Re: Whittaker Corporation Greenville Site
Byproduct Materials License No. SMA-1018
Docket No. 40-7455

RESPONSES TO NRC ADDITIONAL COMMENTS

WHITTAKER METALS - GREENVILLE, PA

CASE 1

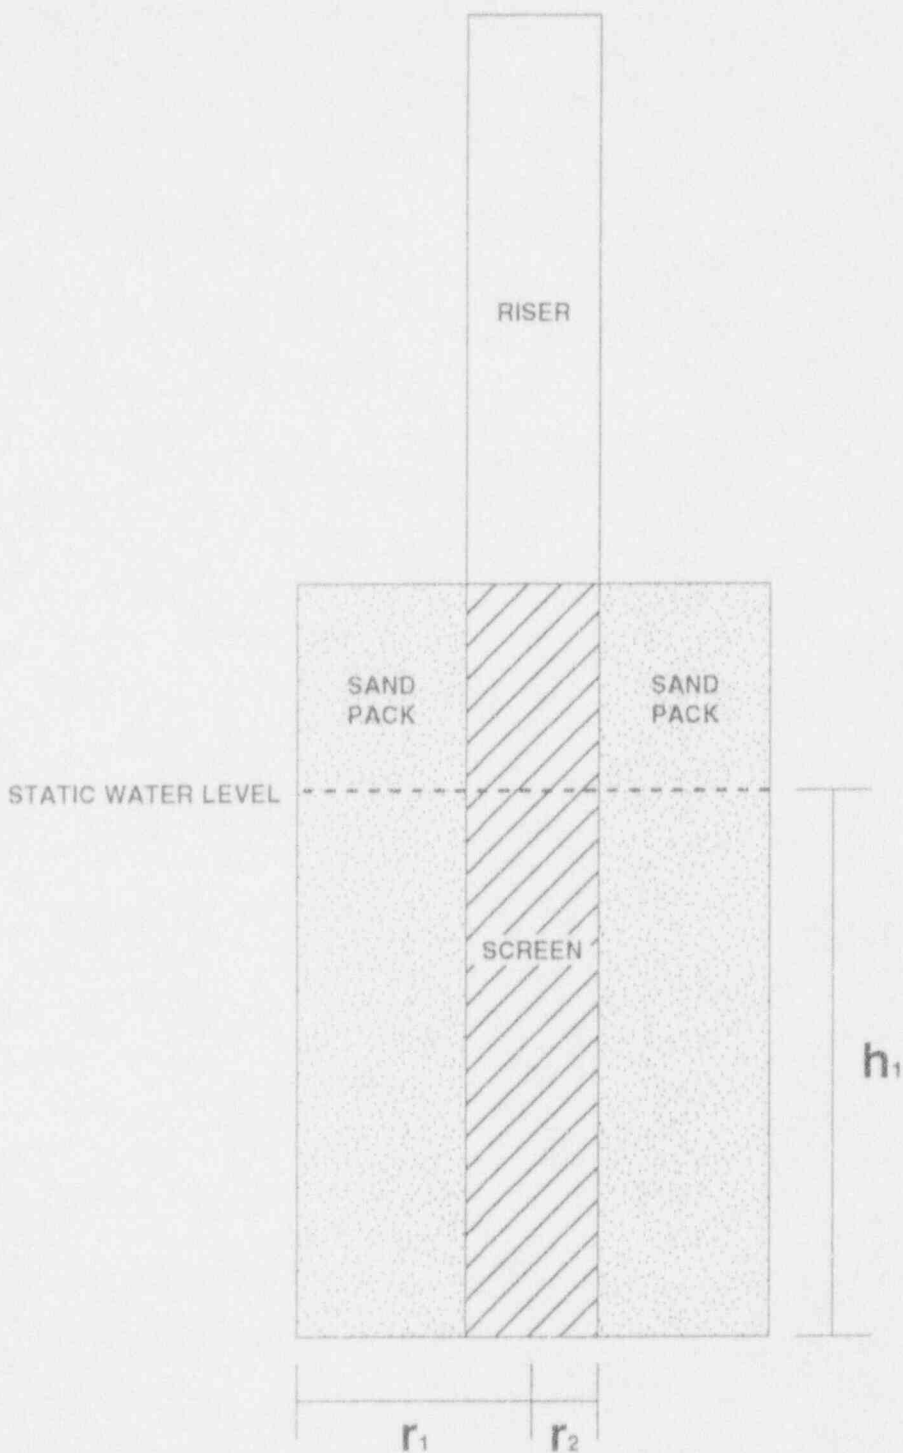
2. The equation for calculating the well volume in Section 9.4.1 has been modified as follows:

Case 1 - **STATIC WATER LEVEL IS LOWER THAN TOP OF SCREEN:**

$$\text{Volume Water in Well} = h_1 \pi (7.48) [(R_1^2 - R_2^2)(\phi) + R_2^2]$$

(See attached Case 1 diagram)

CASE 2
STATIC WATER LEVEL IS HIGHER THAN TOP OF SCREEN

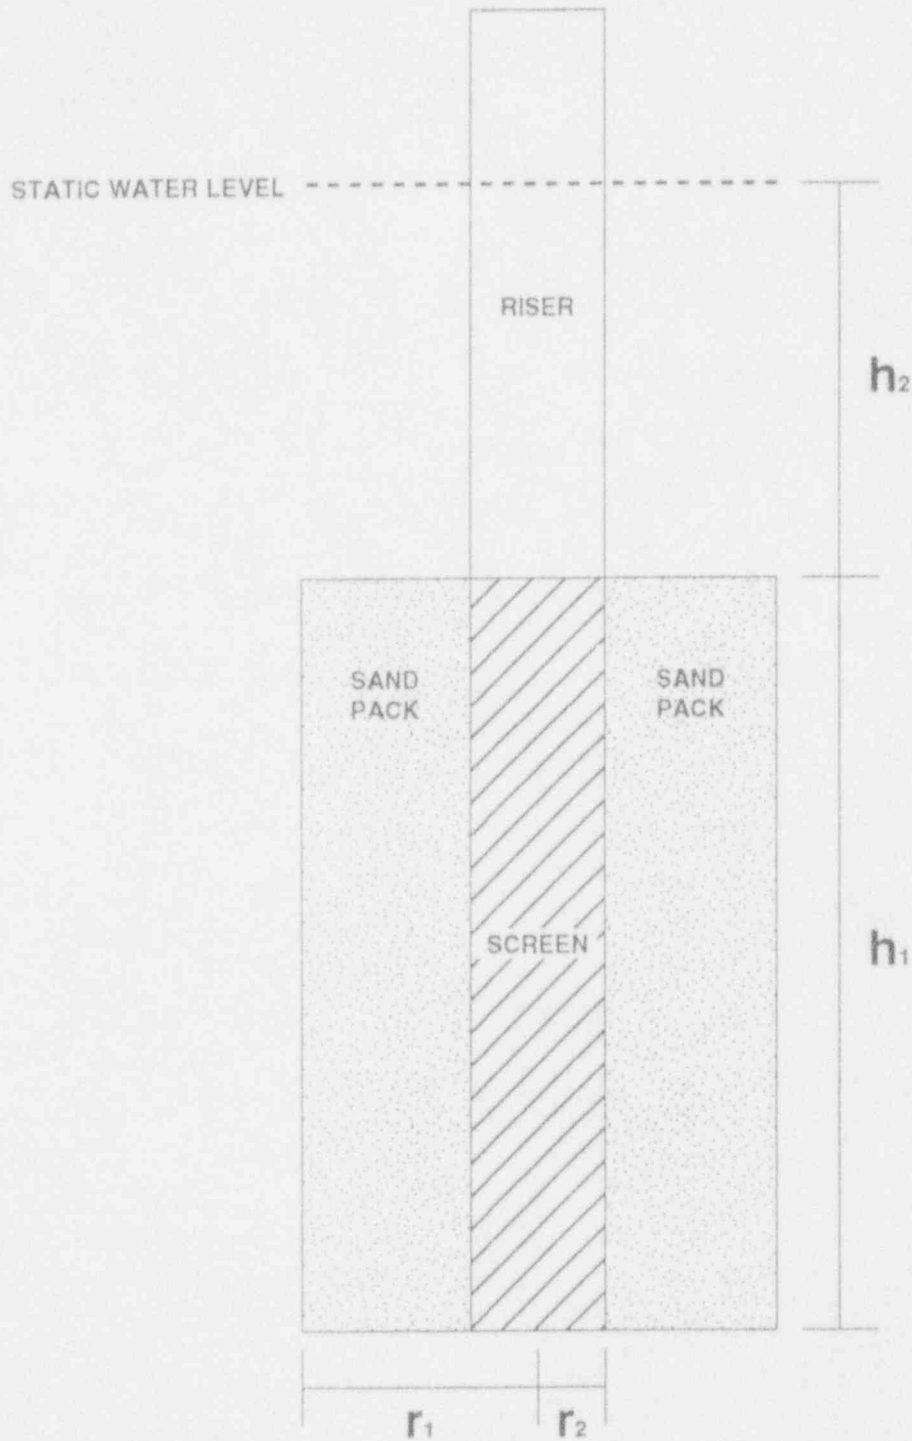
Case 2 - STATIC WATER LEVEL IS HIGHER THAN TOP OF SCREEN

$$\text{Volume Water in Well} = h_1 \pi (7.48) [(R_1^2 - R_2^2)(\phi) + R_2^2] + h_2 \pi 7.48 R_2^2$$

(See attached Case 2 diagram)
